Access Compliance Report

Public Rights-of-Way

Intersection ID: 2412	Main Street: HIDDEN_MEADOW_LN	Cross Street: LAUREL_RUN_DR	Location: E
ADA ID: 9576DA9ADDA6	Ramp Type: PerpDiag	Initial Pass/Fail: Fail	Overall Compliance: No
		Severity Score: 25

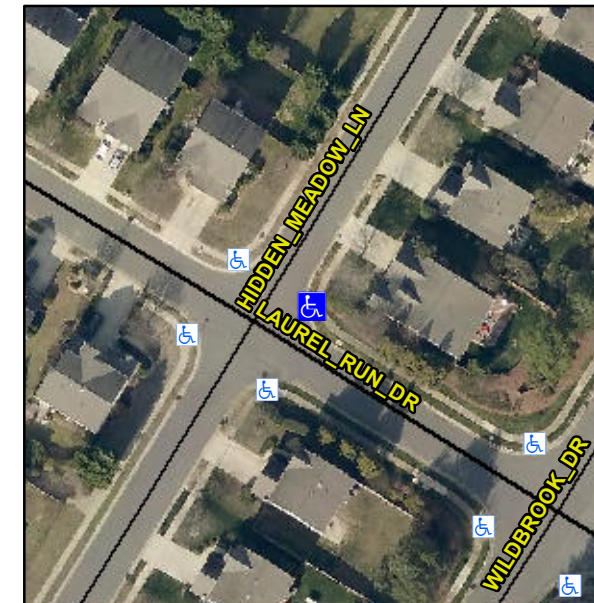
Not Found, R304.2.2, R304.5.3

Compliance	Description	Data	Compliance	Description	Data
N/A	Ramp Length (in)	48.0	No	Ramp Slope (%)	9.1
Yes	Ramp Width (in)	48.0	No	Ramp XSlope (%)	6.4
N/A	Flare Type LT	N/A	N/A	Flare Type RT	N/A
N/A	Flare Slope LT (%)	N/A	N/A	Flare Slope RT (%)	N/A
N/A	Flare Traversable LT?	N/A	N/A	Flare Traversable RT?	N/A
N/A	Landing Length (in)	N/A	N/A	DWS Provided?	N/A
N/A	Landing Width (in)	N/A	N/A	DWS Contrast?	N/A
N/A	Landing Slope (%)	N/A	N/A	DWS Length (in)	N/A
N/A	Landing X Slope (%)	N/A	N/A	DWS Full Width?	N/A
N/A	Landing Curb? (Y/N)	N/A	N/A	DWS Offset (in)	N/A
N/A	Shared Landing?	N/A			
N/A	Gutter Ponding?	N/A	N/A	Gutter Slope (%)	N/A
N/A	Gutter Lip Ht (in)	N/A	N/A	Gutter X Slope (%)	N/A
N/A	Painted X Walk1?	No	N/A	Painted X Walk2?	No
	X Walk 1 Direction	To NW		X Walk 2 Direction	To SW
N/A	X Walk 1 Width (in)	N/A	N/A	X Walk 2 Width (in)	N/A
	X Walk 1 Slope (%)	2.6		X Walk 2 Slope (%)	5.1
	X Walk 1 X Slope (%)	4.4		X Walk 2 X Slope (%)	1.1

Remove & Replace Curb Ramp With Two New Directional Ramps or Equivalent.
